FINAL DRAFT 17 MAY 2022

# Draft Campsie Master Plan Site Specific Review

Joint Panel Report

Figure 16: Option D – Ground Floor Plan

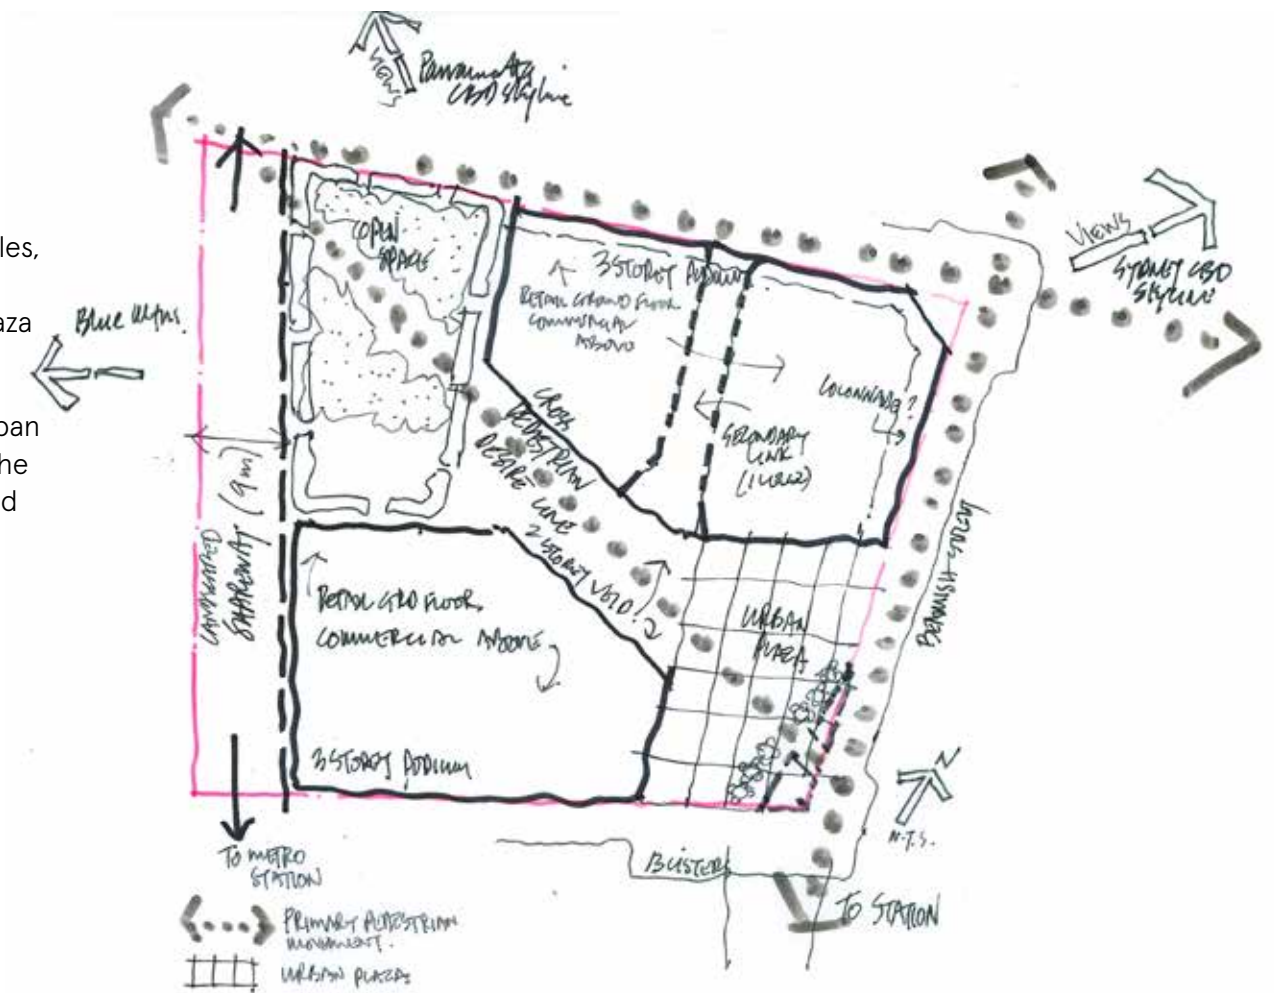
After considering these different options, and in the interest of broadening an understanding of potential approaches, the Panel identified a further potential option. This "Option D" would see built form reinforce the street corner, a 3-storey podium forming street-walls with an urban plaza to the south east corner and a single tower (800m<sup>2</sup>) in a generally north south orientation parallel to Beamish Street and Ninth Ave. Refer to Figure 16 and Figure 17.

A three storey street wall (to all street frontages and a new urban plaza) is consistent with the maximum street wall height contemplated in the draft Master Plan. It would also support increased floor space for employment generating uses, noting that is one of the key principles of the draft Master Plan, to support and catalyse growth of Campsie as a strategic centre. Furthermore, a three storey street wall is an appropriate design response on this site which occupies an entire city block. It would define the street edge at a scale consistent with other main street development and, relative to a lower street wall, would be more effective at diminishing the visual impact of the tower in views from Beamish Street and a new urban plaza.

Taking into account all design considerations, site analysis and Council's testing, the Panel consider that the draft Master Plan maximum FSR control can be increased from 4.5:1 up

to a maximum of 4.9:1. Development up to this maximum would enable an optimal development outcome which is consistent with other draft Master Plan controls and principles, is appropriate in the context and includes the potential for additional public benefit in the form of new public urban plaza addressing Beamish Street.

Figure 22: Site C2 FSR

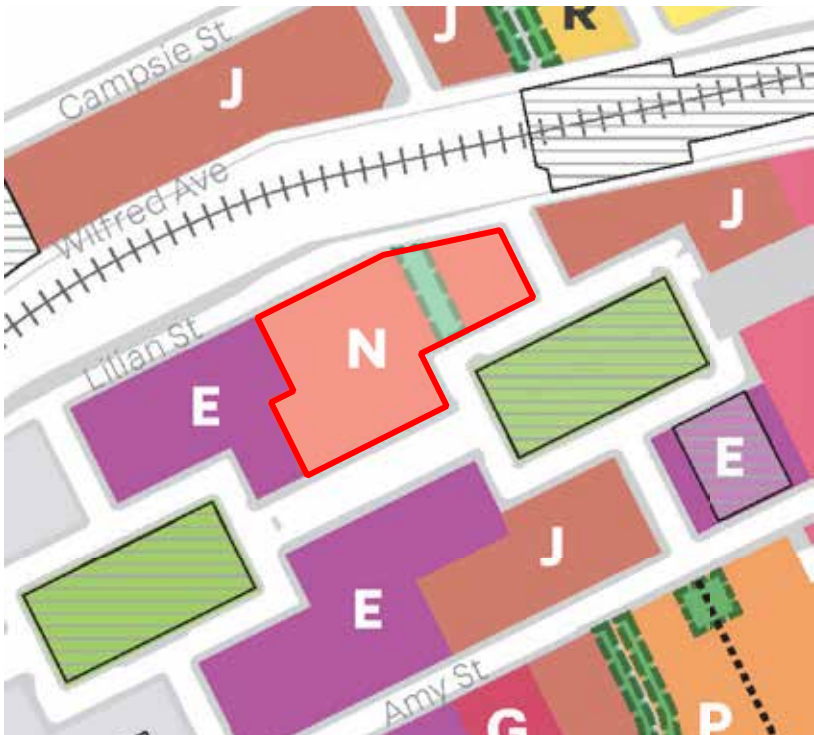
The modelling confirms that the Panel's preferred built form outcome can be achieved with the 3.2:1 FSR currently proposed in the draft Master Plan. There is potential to take better advantage of the incentive floorspace provisions for underground space and address urban design issues, as outlined below.

- Maintain the maximum FSR of 3.2:1 for above ground floorspace with an additional 1:1 for certain uses (including a registered club) if located below ground. With a revised approach including redevelopment of the existing RSL club and relocation of parts of it below ground, this would provide a development yield similar to the yield proposed.
- Maintain the maximum height at 16 storeys as per the draft Master Plan.
- Provide a maximum street wall height of 4 storeys to the Anglo Road frontage.
- Support the proposed 8m wide pedestrian link from Anzac Square to Lilian Street.
- Support the nil and 6m setbacks to Anglo Road to provide landscaping along part and define the edge to Anzac Park.
- Support the proposed ground level residential along the Lilian Street frontage.
- Require active frontages to Anzac Parade, Dewar Street and both sides of the new pedestrian link.

Figure 24: Section showing solar and visual impacts on Anglo Road Properties

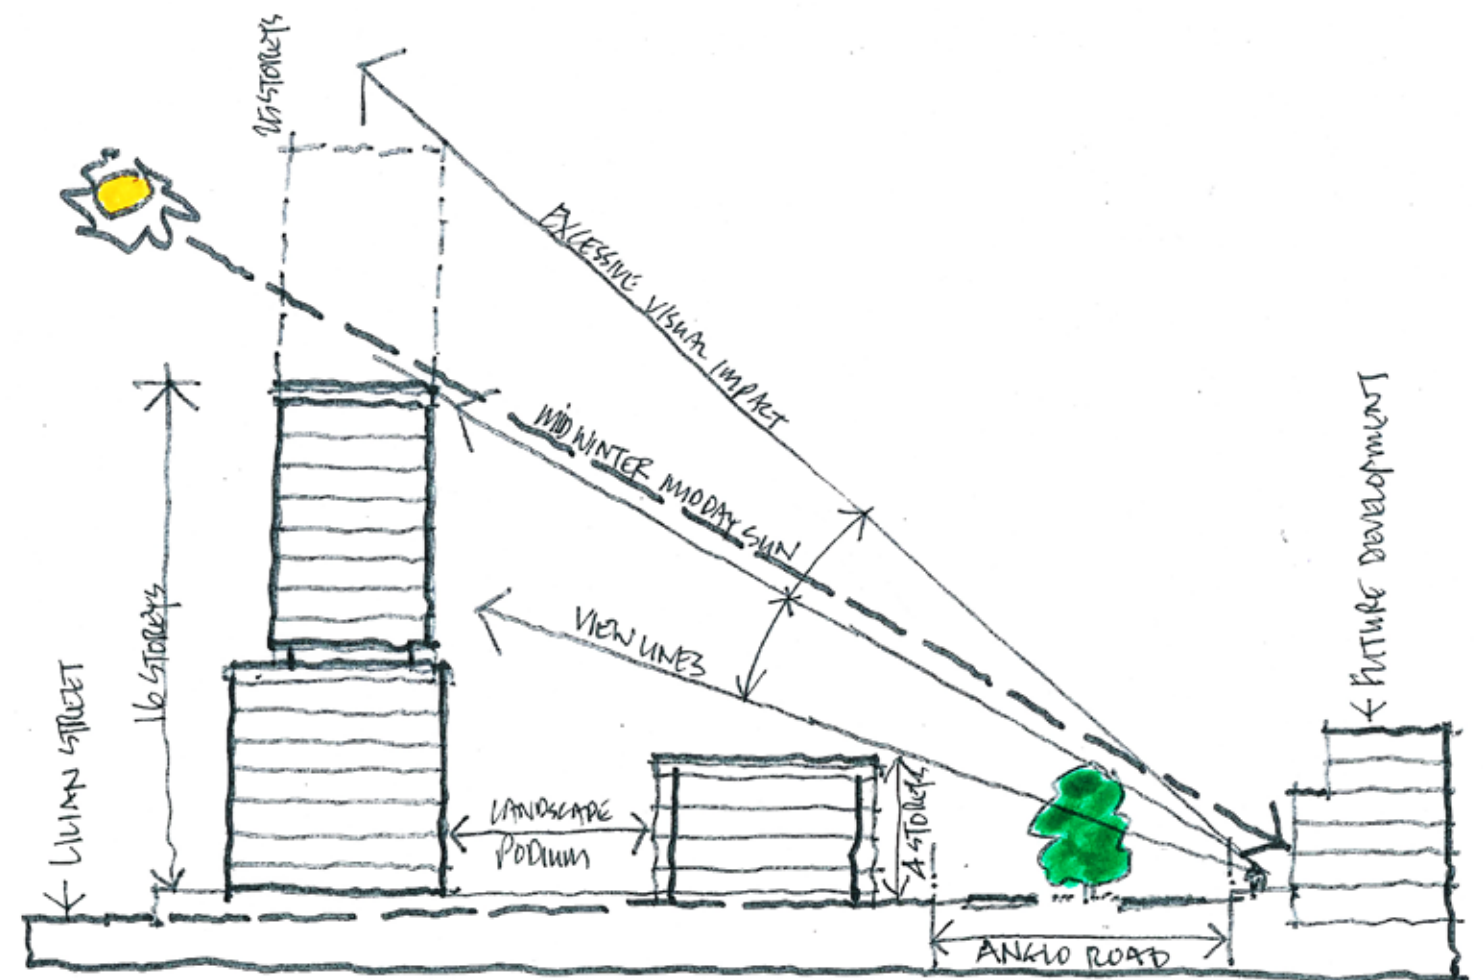
The proposal demonstrates acceptable overshadowing impacts for Anzac Square, Carrington Square and surrounding streets. However, the proposed 25 story tower would result in shadow impacts for future development to the south side of Anglo Street which the draft Master Plan seeks to avoid.

A higher building may be possible in the north-east corner of the site (west of the laneway) The proposed 4 storeys could potentially reach 8 storeys. If this approach were pursued the building length along Lilian Street would need to be addressed in design development.

Figure 25: Built form with defining edges to ANZAC Park and active frontage

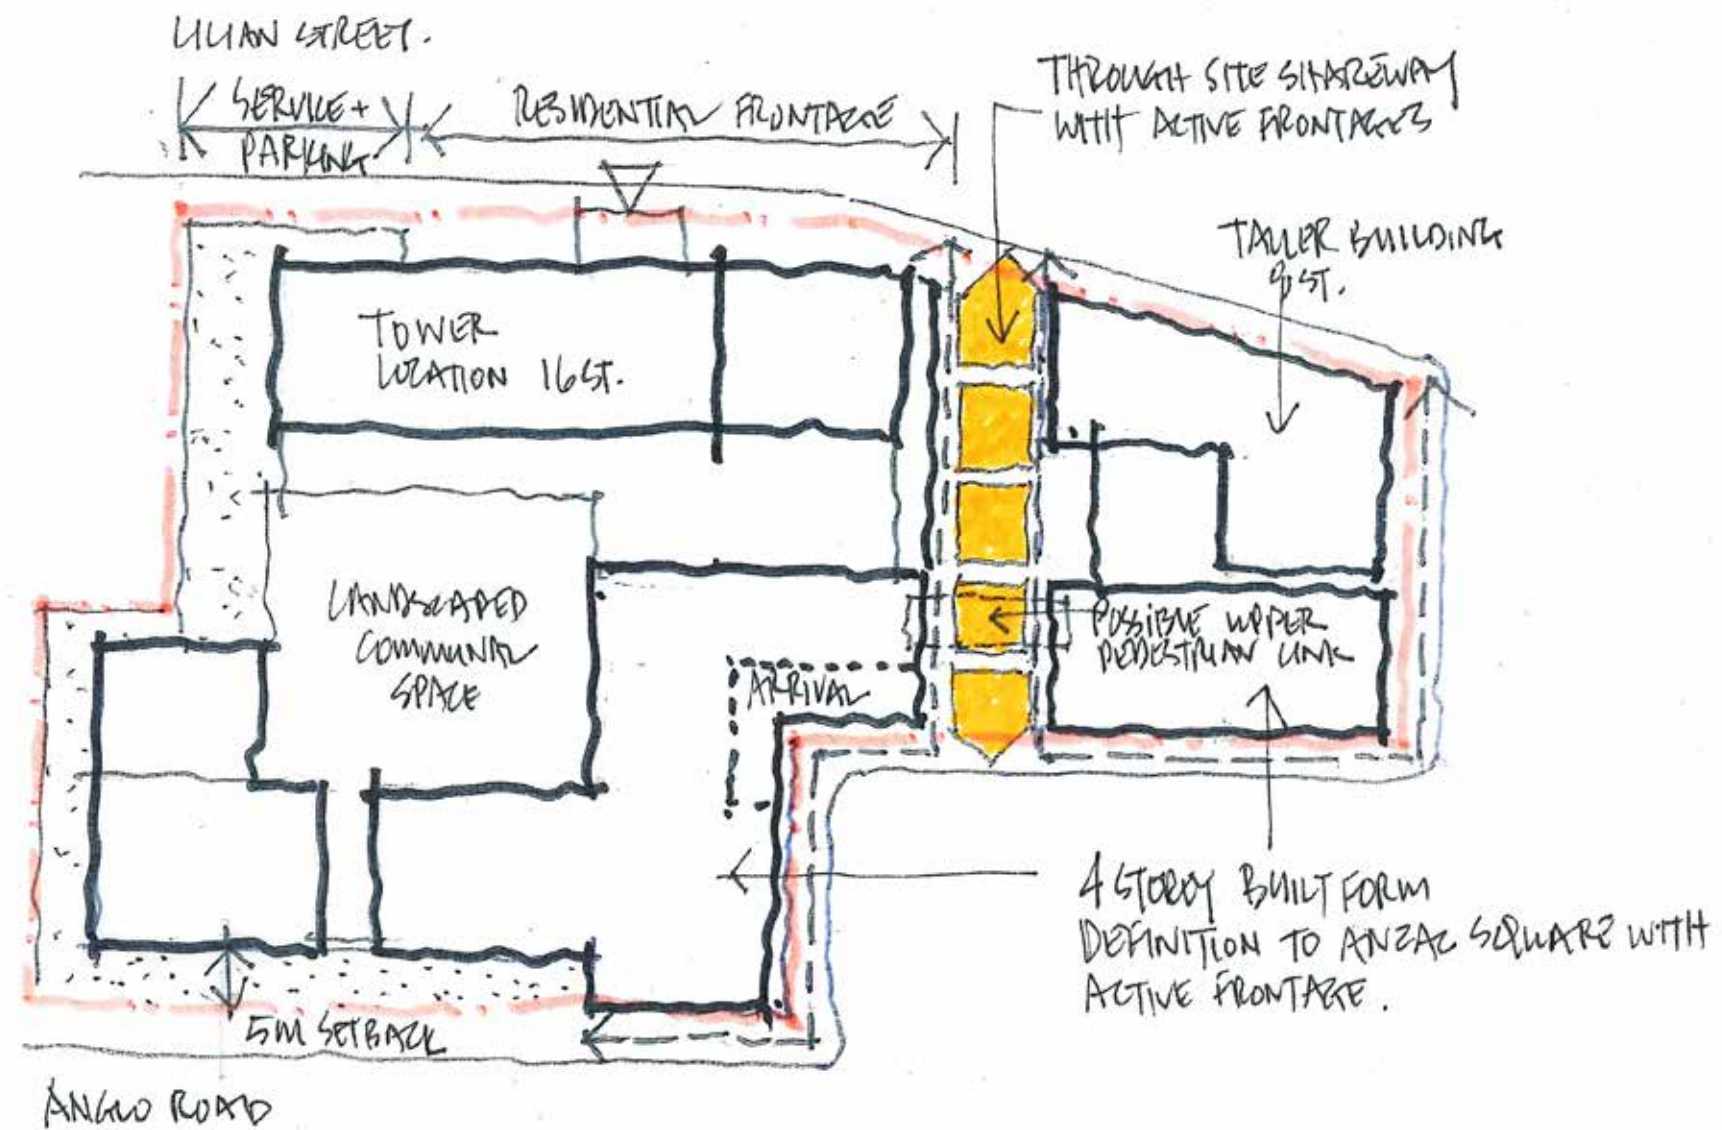
Despite these commercial factors, this approach limits preferred built form and urban design outcomes for the site. A more holistic approach to redevelopment may provide the opportunity for:

- a 4 storey street wall to Anzac Park, for more consistent building edge to the park, consistent with the draft Master Plan;
- relocation of some or most of the Club floor area below ground, providing for a greater yield, consistent with the intent of the draft Master Plan; and
- a more considered approach to activating the Dewar and Lilian St frontages, refer to Figure 25.

Figure 31: Ground floor plan showing recommended setbacks and key links

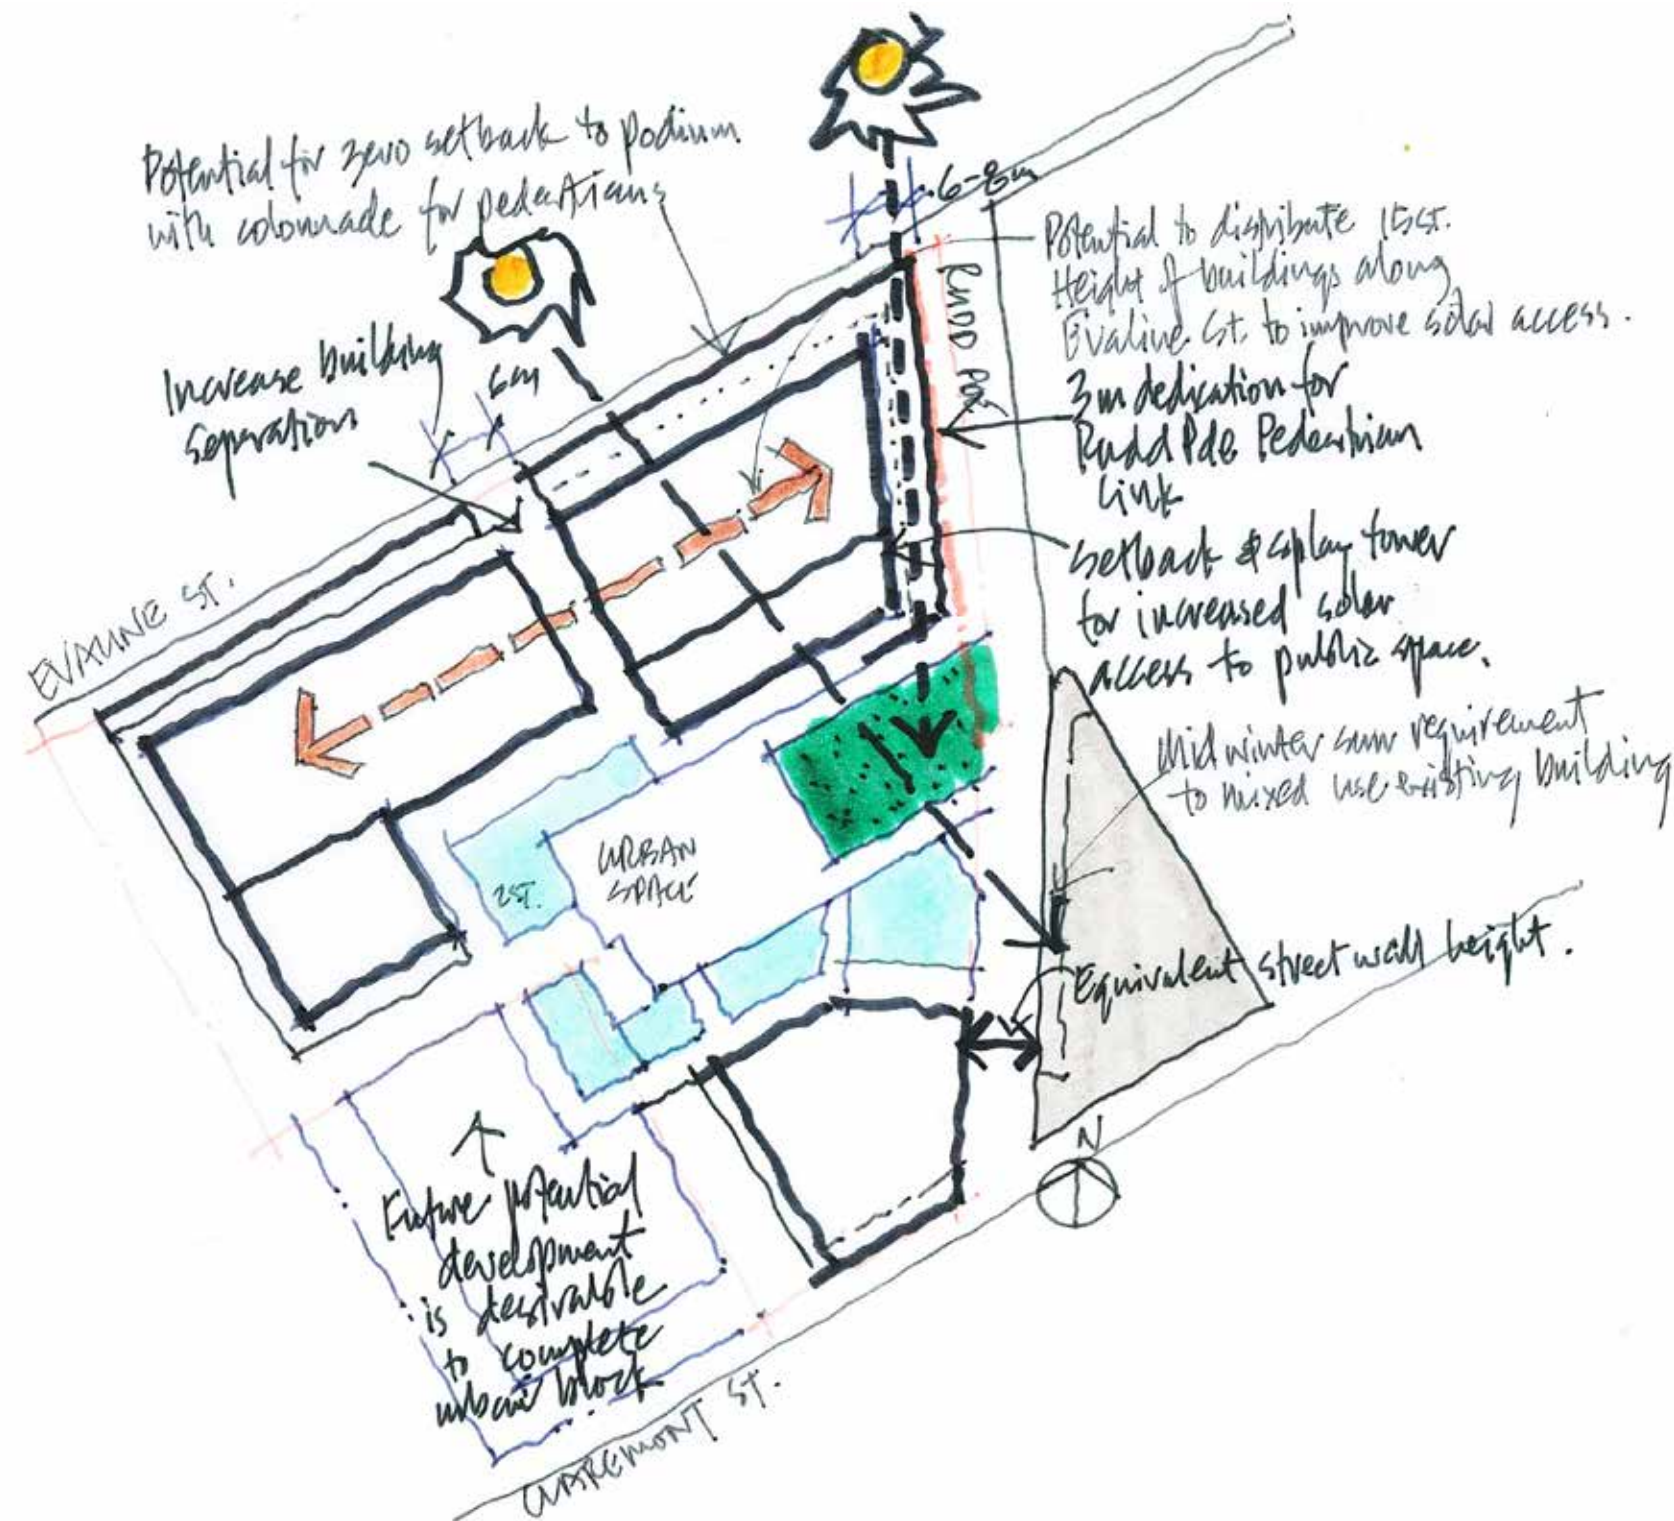
The overall scheme has well considered urban design merits. It would be considerably enhanced by inclusion of the three adjacent sites to the west on Claremont Street. A more regular block and built form would then define the south-west corner and provide better enclosure of the proposed central urban space.

There are substantial Plane trees along Rudd Parade near Evaline Street. Adequate setbacks from these trees should be examined together with the potential for the proposed deep soil zones to protect existing trees on site.

The Panel recommend modifying the draft Master Plan height control to allow for a 15 storey tower to be located anywhere along the Evaline Street frontage to optimise solar access to the urban space and adjacent development. Related floor plate and built form separation controls are recommended to control building bulk while providing maximum flexibility during design development. The 3m building separation between the 15 and 8 storey buildings fronting Evaline Place is inadequate. It should be a minimum of 6m to improve airflow, noting that compliance with SEPP 65 and the ADG may require greater separation at development application stage.

- Provide a minimum 6m separation between the tower and lower built forms fronting Evaline Street.
- Dedicate a 3m wide strip of the north eastern corner of the site (total of approx. 180m<sup>2</sup>) for a consistent 6m width to Rudd Parade.

The above recommendations are shown in Figure 31

Figure 39: Recommended setbacks

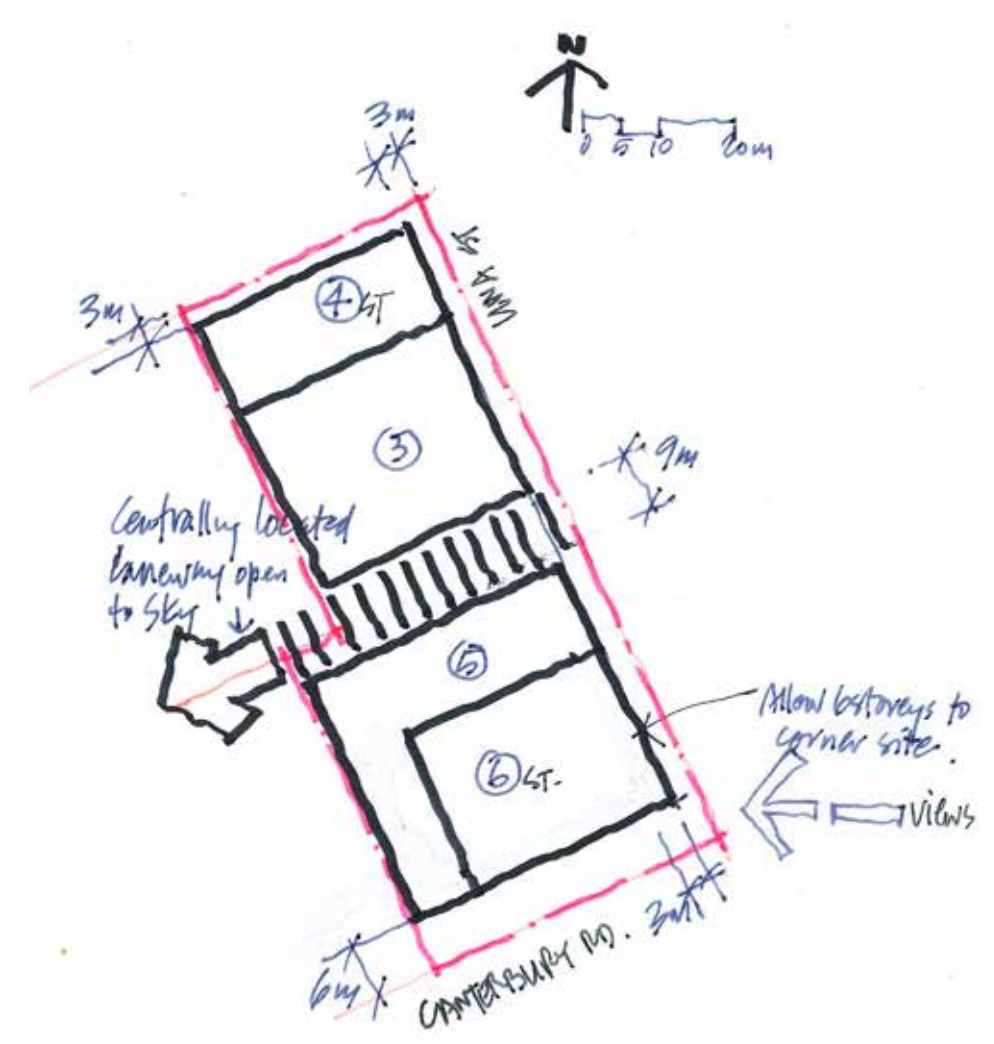
Residential uses are prohibited in the B6 zone which encourages a range of commercial and employment generating uses, particularly those with a medical focus. The Panel agrees with this direction of the Master Plan and does not support the proposed introduction of residential uses on this site.

A continuous centrally located laneway open to the sky is considered essential to service commercial uses fronting both street and to break up the scale and built form of development within the block.

In terms of built form the Panel considers that this corner site can support 6 storeys to Canterbury Road and 4 Storeys to Perry Street. This will strengthen and 'bookend' the large corner site, without disrupting a step up in height through to Beamish Street. It also provides some variety and massing modulation of the form of buildings addressing the streets. The Panel's recommendation for a minor increase to the FSR responds to this modified built form.

- Retain existing B6 Enterprise Corridor zoning
- Allow FSR of 2.0:1 (south of laneway) and 1.5:1 (north of laneway).
- Maintain 6m setback to Canterbury Road, consistent with approach along this length of the corridor.
- Retain street setbacks as per draft Master Plan
- Allow heights of:
  - 6 storeys on the corner of Canterbury Road and Una Street, stepping down to 5 storeys to address the site's western boundary and central laneway; and
  - a majority of 3 storeys for the part of the site north of the central laneway, stepping up to 4 storeys on the Perry Street frontage.

Refer to Figure 39.
